Landscape Consultation

Proposal: Discharge of Condition 7 (Landscaping) of 20/00849/FUL.	**Location:** Manor Farm Church End Woodwalton Huntingdon PE28 5YU
Case Officer: KSI **Landscape Officer:** PBAI	**Application No:** 24/80412/COND

Documents Viewed:

- External Landscaping Plan 001A
- Landscape Management Plan
- Superseded External Landscaping Plan

MIXED NATIVE HEDGEROW PLANTING DETAIL - 5/m
Double staggered row with 800mm trench
Not to Scale

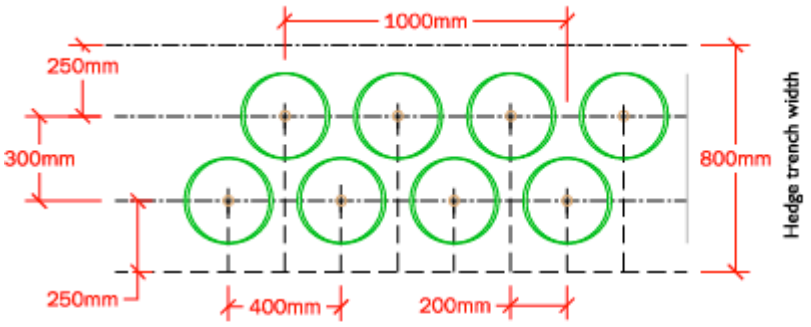
H1 Beech hedge single species should be replaced with a mixed native species hedgerow with species characteristic of the Fens LCA. This should be a minimum of 5 species (ideally more) planted at 5/m in a double staggered row as illustrated below. This could be a combination of the following species: *Crataegus monogyna, Corylus avellana, Cornus sanguinea, Prunus spinosa, Ligustrum vulgare, Viburnum opulus, Rosa canina and Frangula alnus.* Amendments to the species accepted. Further amendments required to possible typographic error suggesting 400 – 600cm trees. Please amend to 40 – 60cm.

H1 Mixed Native Hedge (double staggered row)

The hedge shall be planted in a staggered row at the above dimensions
